**CLARKE COUNTY PLANNING COMMISSION
TABLE OF CONTENTS
April 6, 2018 Business Meeting**

MAJOR SUBDIVISION (S-17-01)

Coquette Estates Subdivision

**RE: Coquette Estates
Road Construction Plan**

DRAINAGE AREA MAP 1"=1000'

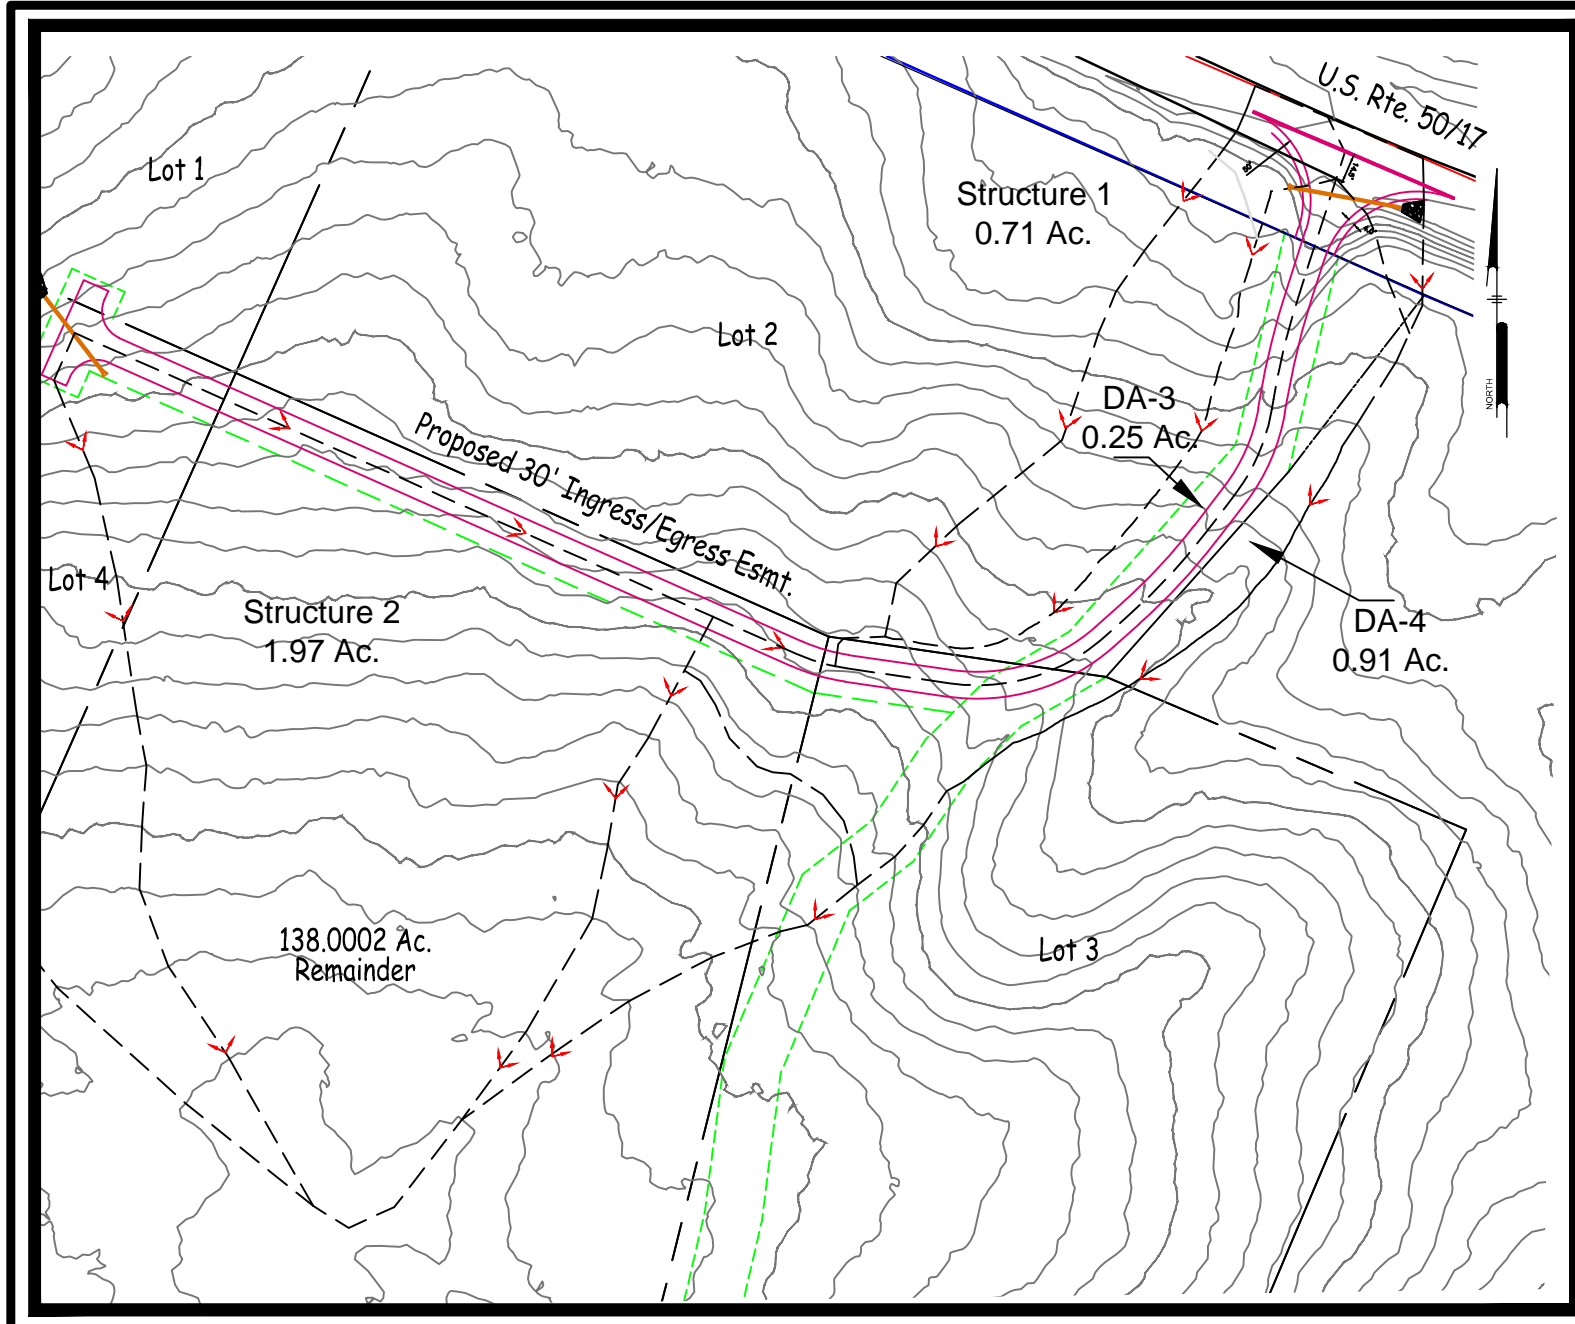
1. Comment: Addition of the drainage map on Sheet CS0001 is acknowledged. Please provide a title for the map and indicate the map scale.

Response: The map now has a title and scale.

PLAN & PROFILE

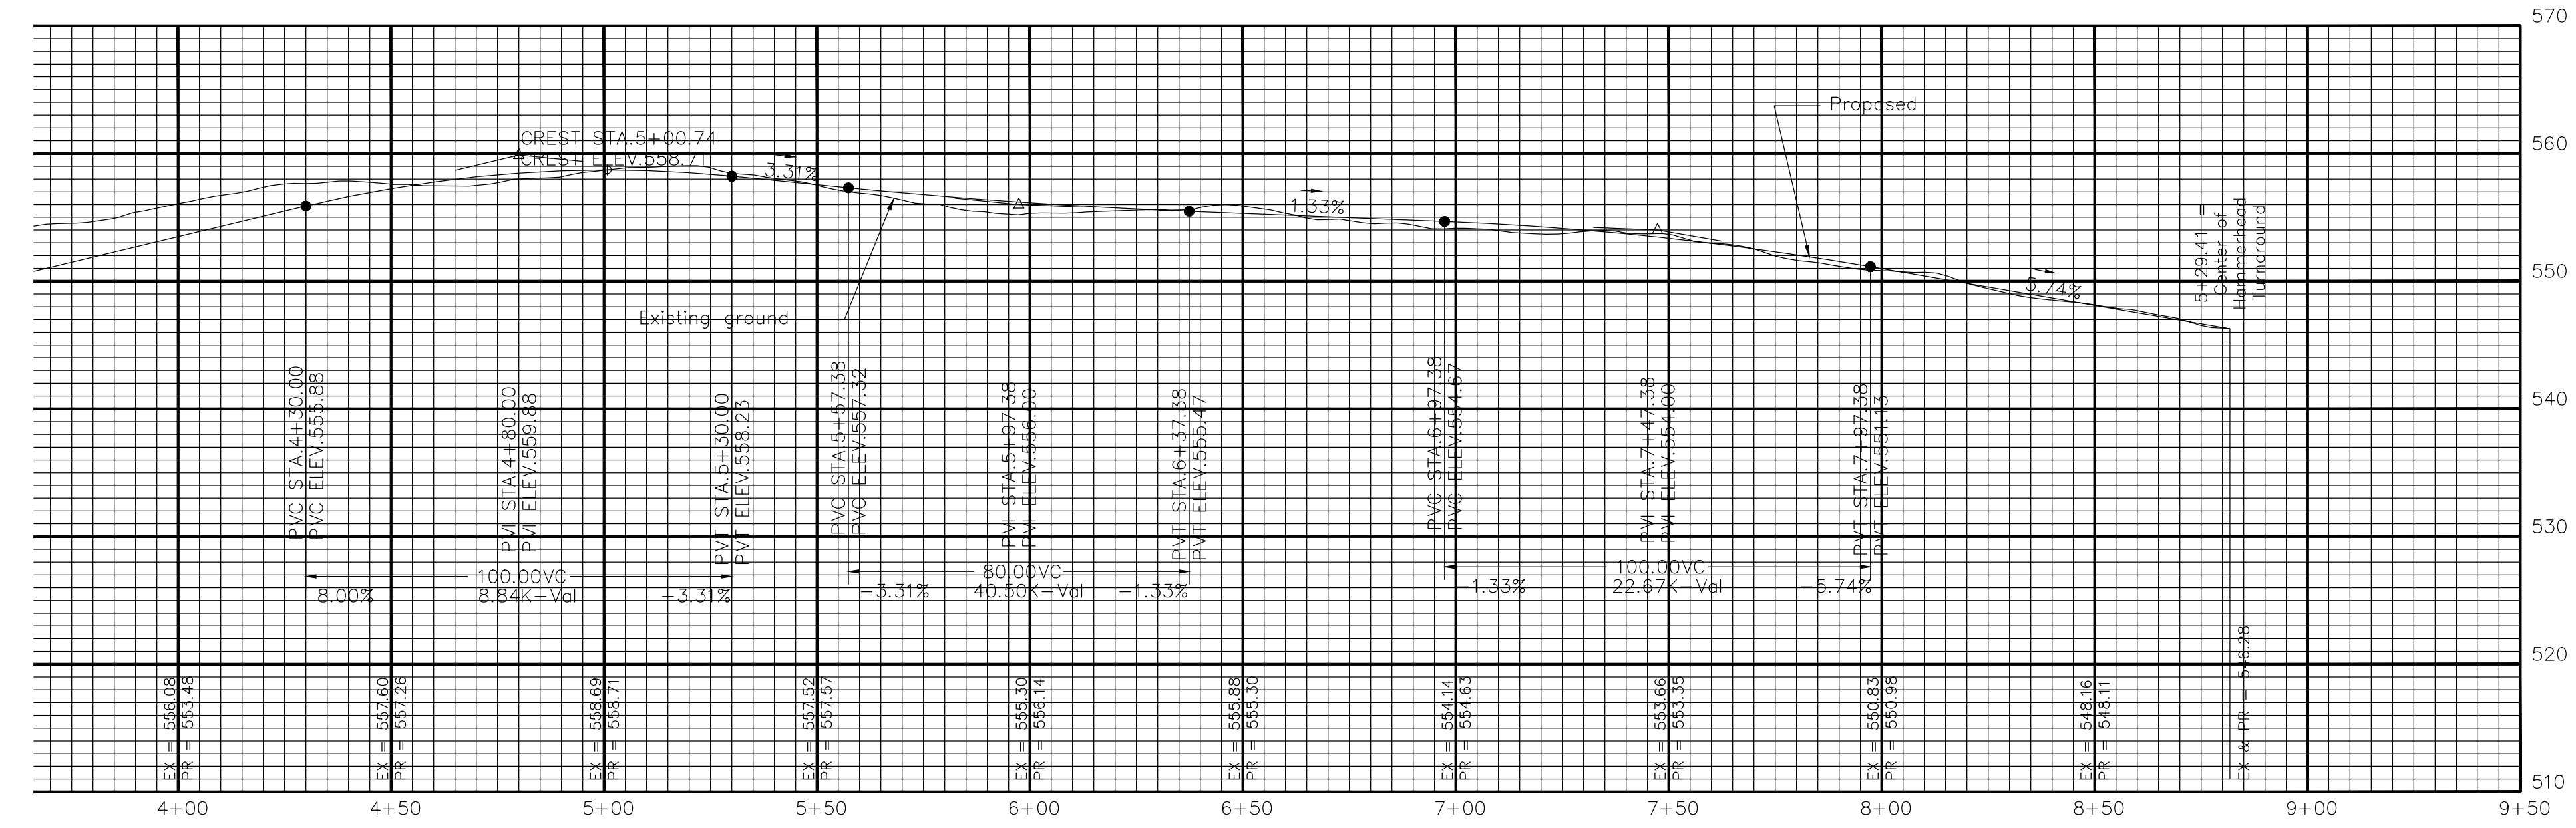
4. Repeat comment. The designer should include the provided stopping and intersection sight distances per 8-J-2-c 5 (for the new section of road). VDOT will require sight distance confirmation at the proposed low volume commercial entrance.

3. Comment: Repeat comment. Applicant has indicated that the 0.35 weighted c-value is conservative for the amount of impervious that will be constructed in the drainage areas. Please provide an estimate of the impervious additions (and the associated weighted c-value calculations) in order to verify this. Without the amount of impervious area shown or accounted for, there is no way to verify is 0.35 is in fact conservative.

Response: Stopping sight distances meet the minimum requirements in the Ordinance. K values have been added to the Crest vertical curves. K values greater than 2 meet the minimum stopping distance of 65 feet. The proposed entrance meets the minimum sight distance requirement of 610 feet. A profile has been added for verification.

Response: Weight C calculations are now provided. Structure designs have been revised to reflect these values.

CS1000

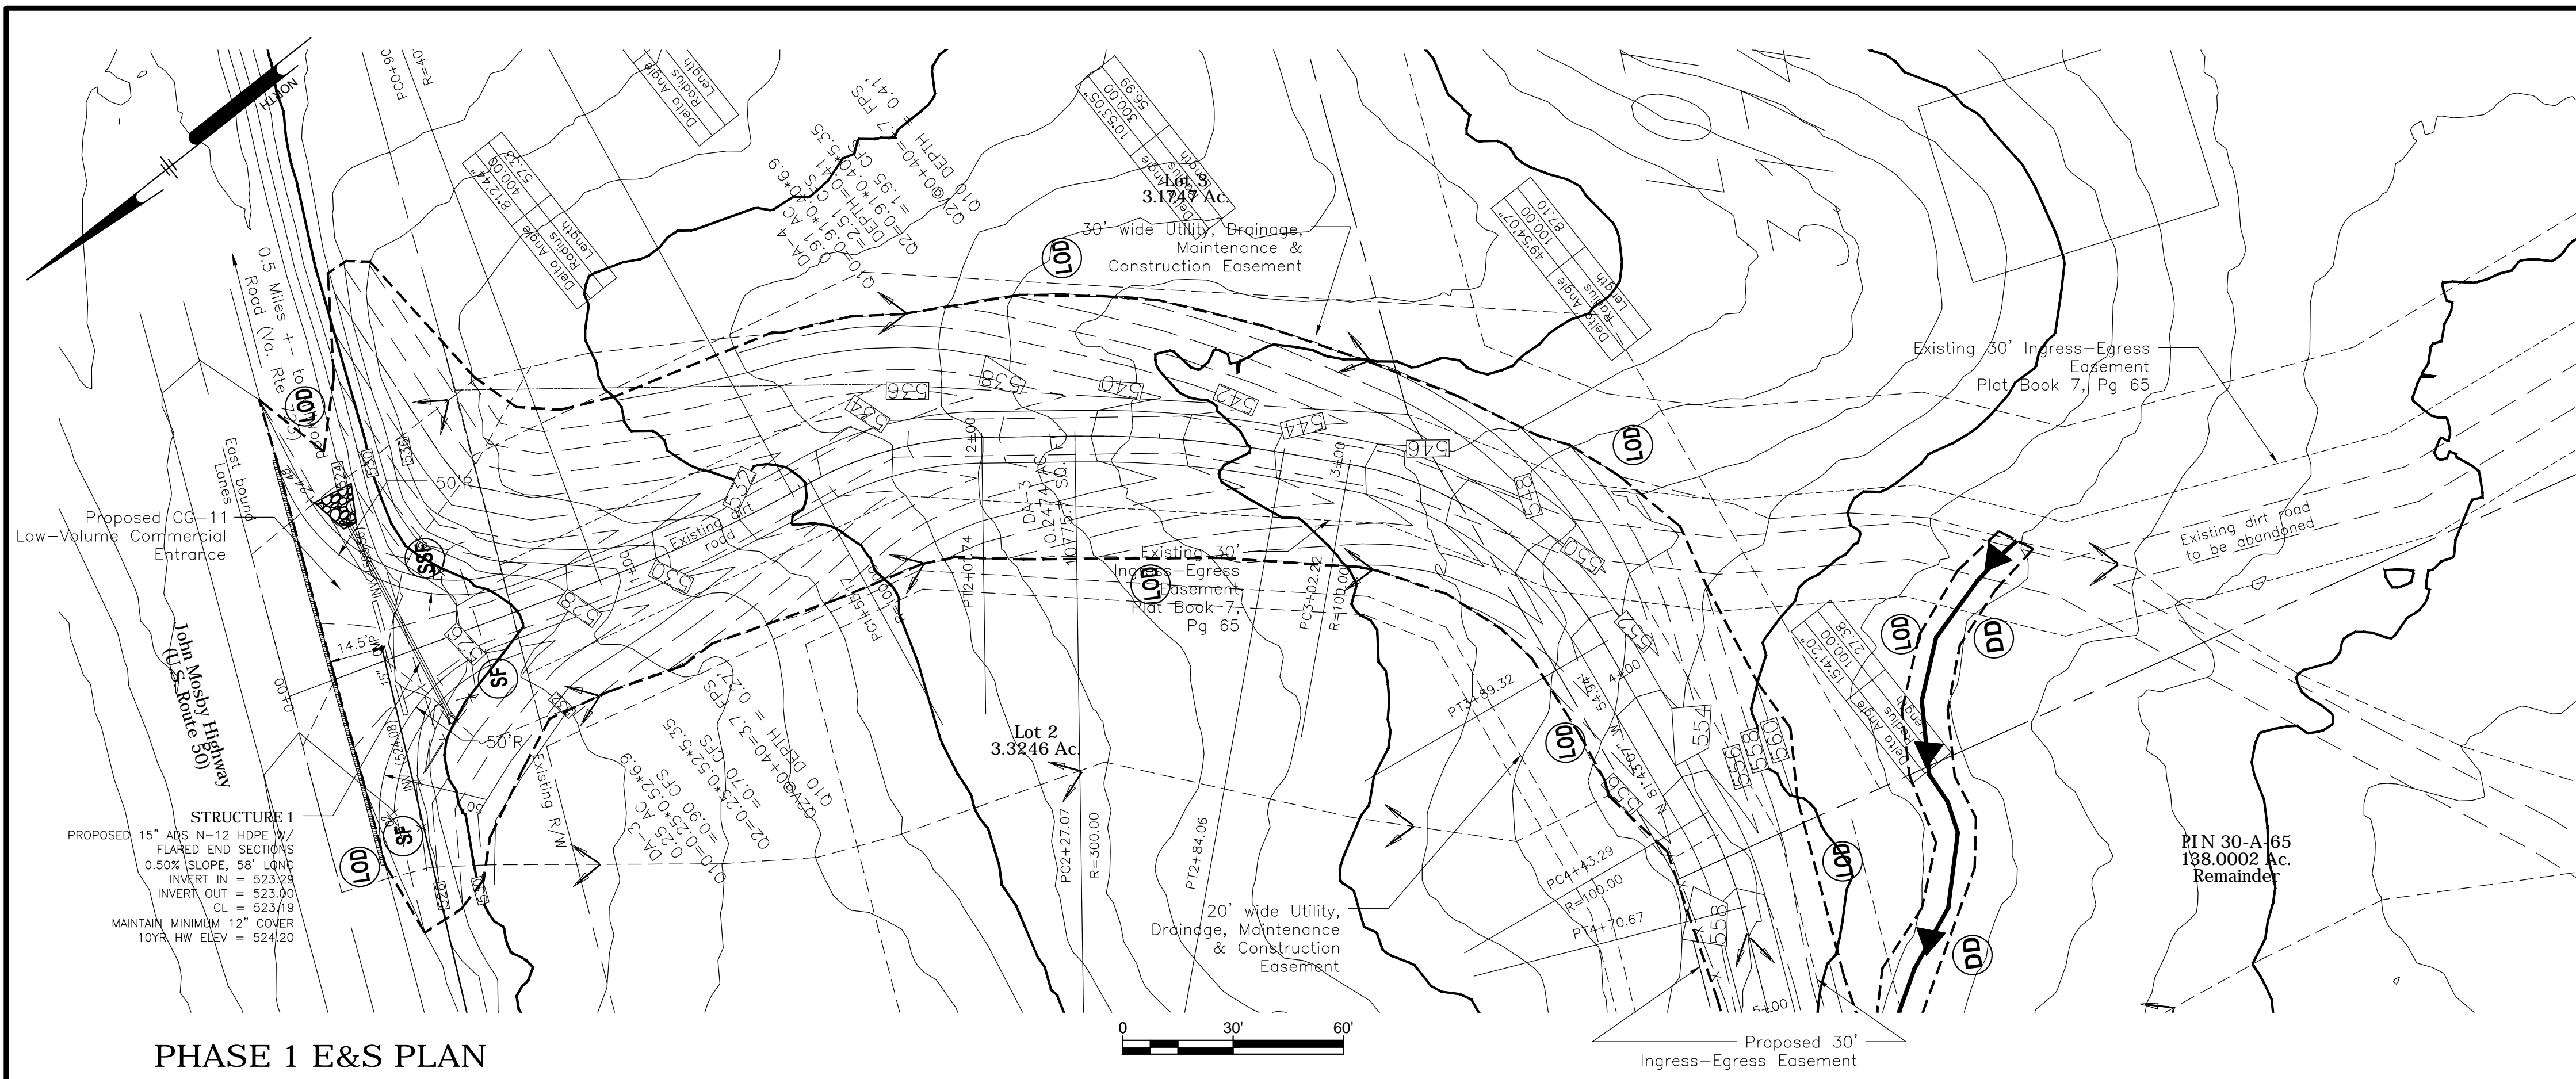
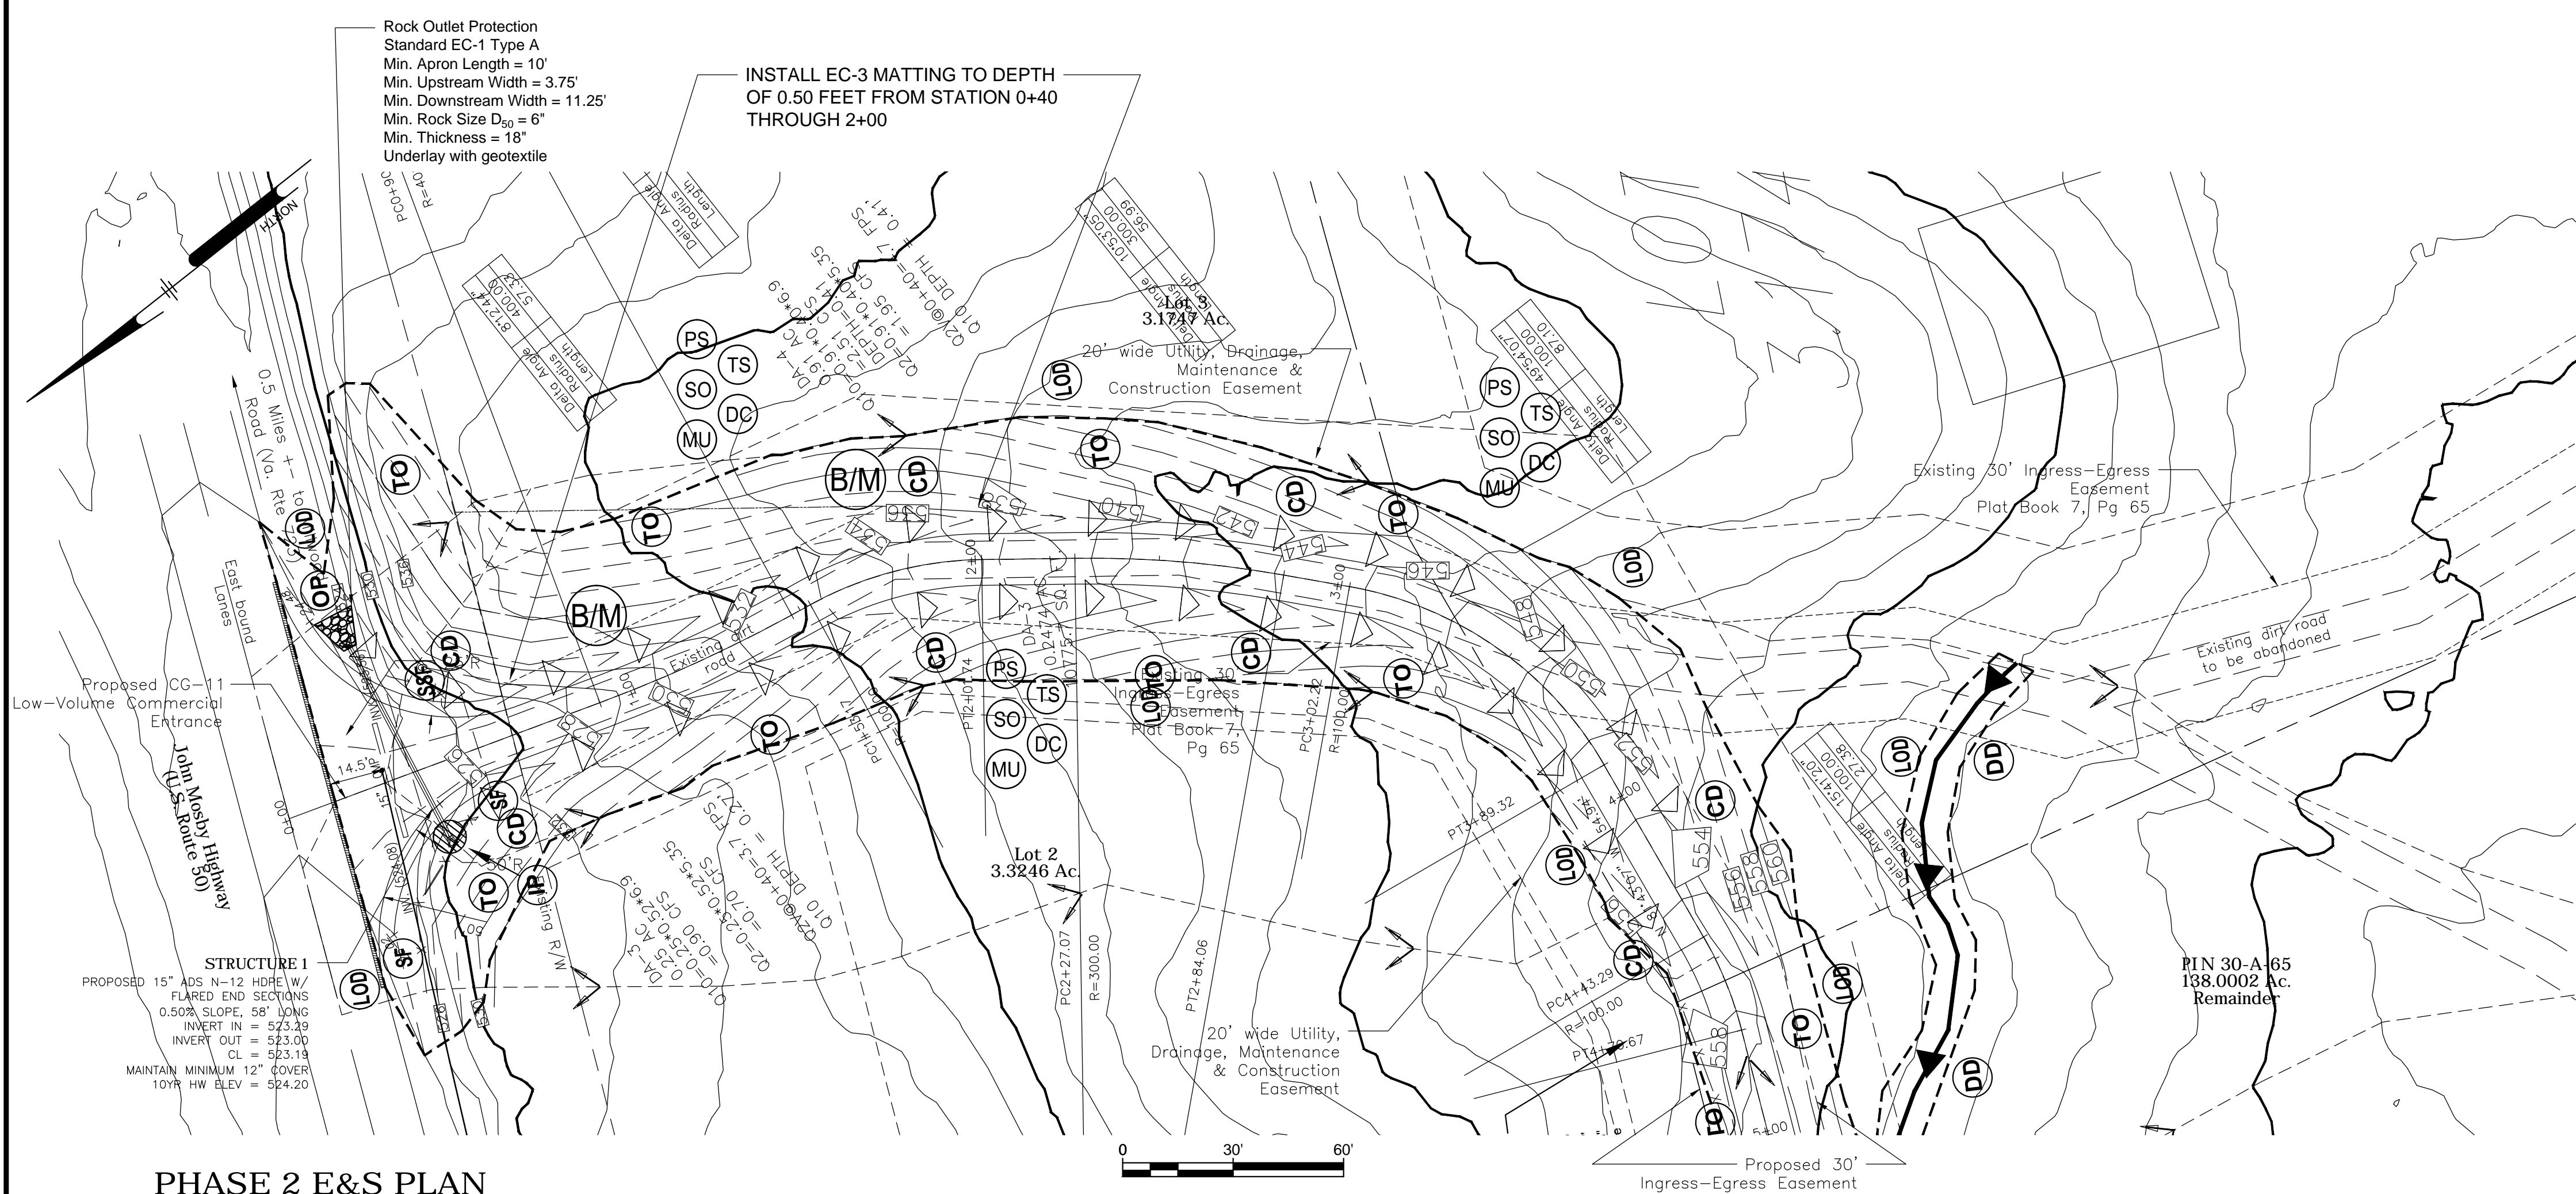
1. No further comment
2. No further comment
3. The existing road (noted to be widened) now shows a maximum grade of 10%, which is still in excess of allowable grade per County Ordinance Section 8-J-2-c-4. VDOT may also have comments regarding the slopes of the entrance and the portion of the road in the right-of-way area.

13. Comment: EC-3 matting is shown on Sheet CS8003 in the north side ditchline from Station 0+40 to Station 2+00. We are uncertain if this is a special design for the EC-3, since Note 4 on Plan Sheet CS1000 indicates that EC-3 is required in all ditches exceeding 4% slope. If EC-3 is to be called out graphically, it should be called out in all required locations.

Response: The road has been redesigned to provide a maximum grade of 8%. VDOT has commented on the entrance and those comments have also been addressed.

Response: Note 4 on Plan Sheet CS1000 has been removed.
